## Field Safety Notice

Reference: R546

This voluntary Field Safety Notice (FSN) is to inform you about a Field Safety Corrective Action (FSCA) for the AR-9800 Synergy RF Console.

New label

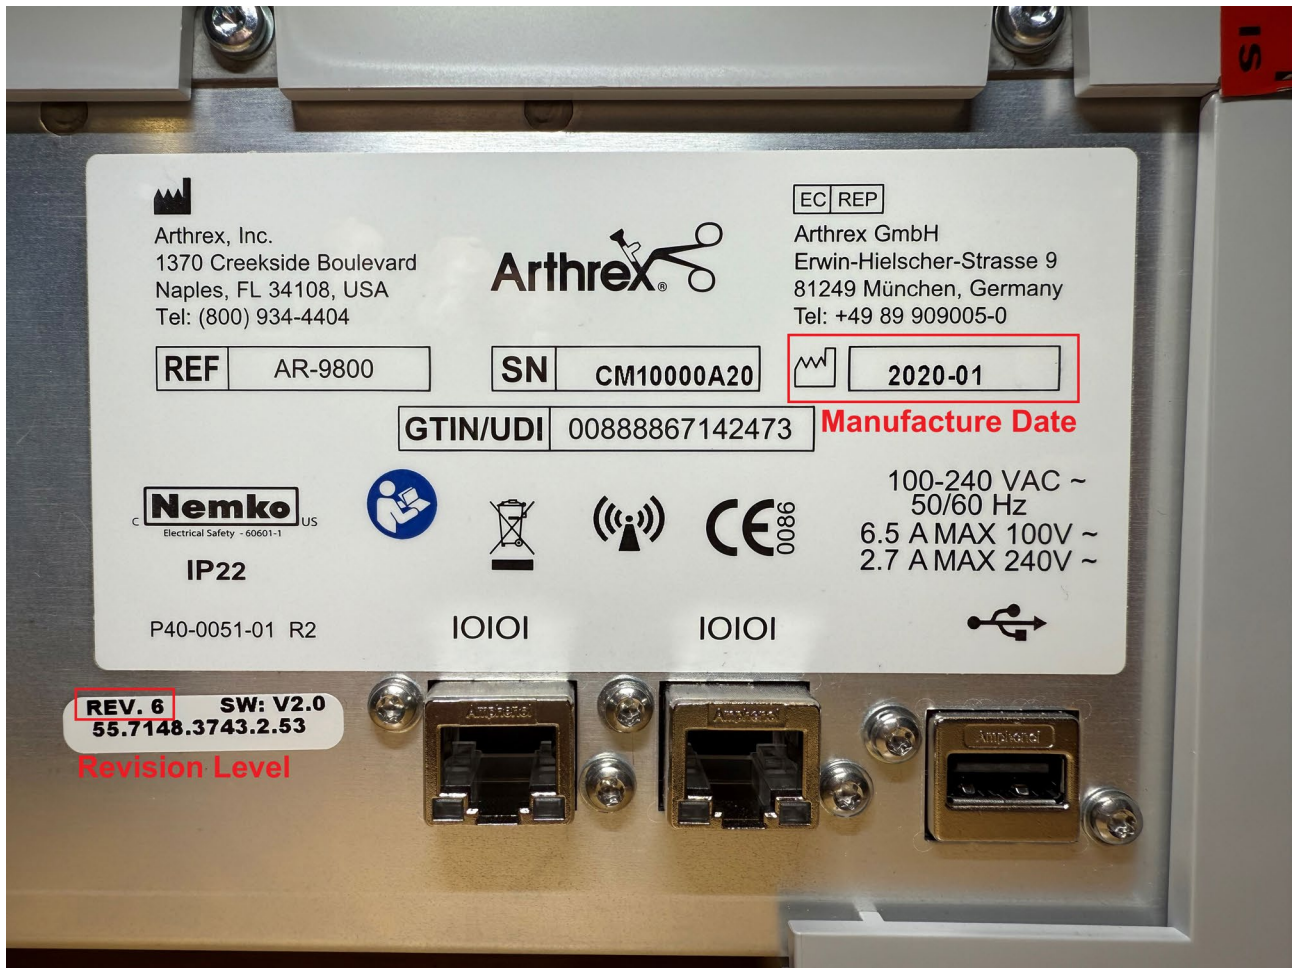
To resolve this issue, an Arthrex employee will replace the current T8A fuses with new F4A fuses and relabel the device with new fuse specifications.

1. Immediately identify the indicated AR-9800 you have in your control. The affected devices can be identified via a label on the back of the device that indicates the revision level (see picture below). If the revision level label is not present, the device should be considered affected if the manufacturing date is prior to July 2020. The manufacturing date is indicated on the main label on the back of the device.
